Service Bulletin No. SB-AG-002
October 17-1977

SUBJECT: REPLACEMENT OF BETA LIGHT MICROSWITCH

PURPOSE: To provide instructions for replacement of the beta light microswitch with an improved microswitch installation.

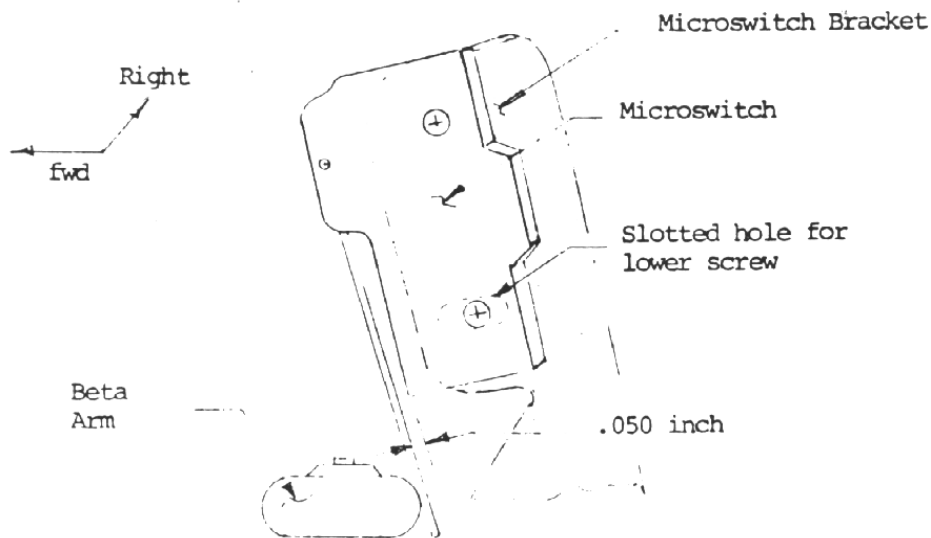
4. Remove the hub puller before adjusting the microswitch.
5. For the initial adjustment of the microswitch, position the body of the microswitch as shown on the sketch below:

Use the lower mounting screw to adjust the microswitch so that the operating lever is within .050 inch of the microswitch body with the brass low stop collar in its full aft (normal ground) position. This is an initial trial setting.

Microswitch and Bracket Installation

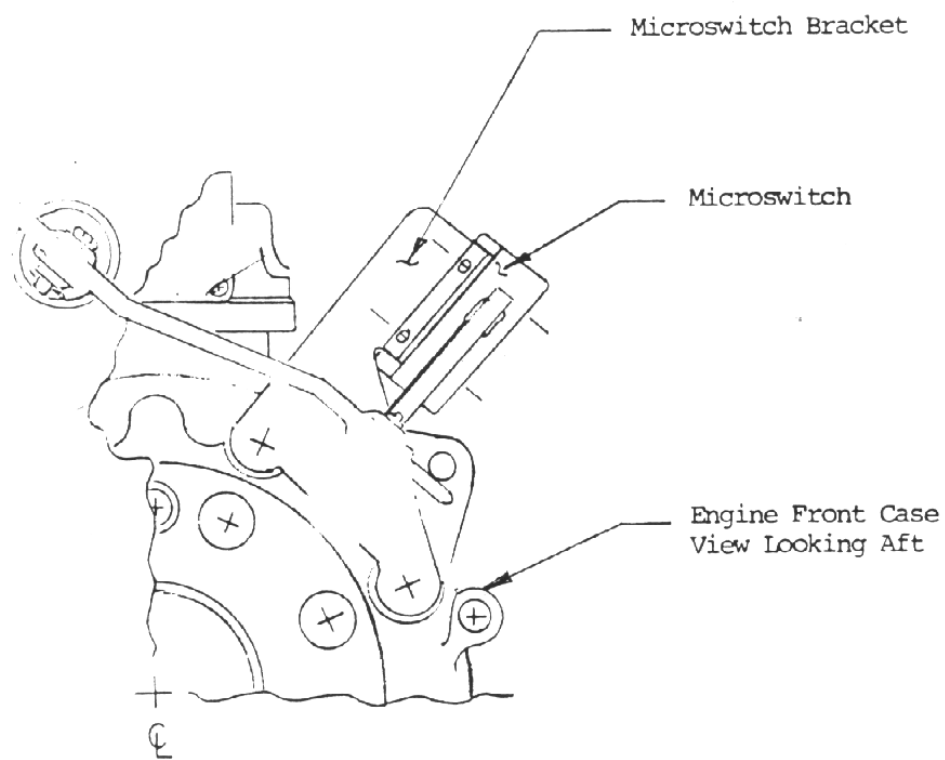
3. Remove and replace the existing beta light microswitch and bracket with the new microswitch and bracket that are supplied with the kit. Reconnect the wire terminals to the "common" and "normally closed" screws on the back of the microswitch. (See Attachment I for installation).

Mount microswitch and bracket on the front case of the engine as shown above. Be sure and attach the microswitch bracket to the engine with the flange facing forward. Retorque mounting nuts 145 in-lb min. to 165 in-lb max.
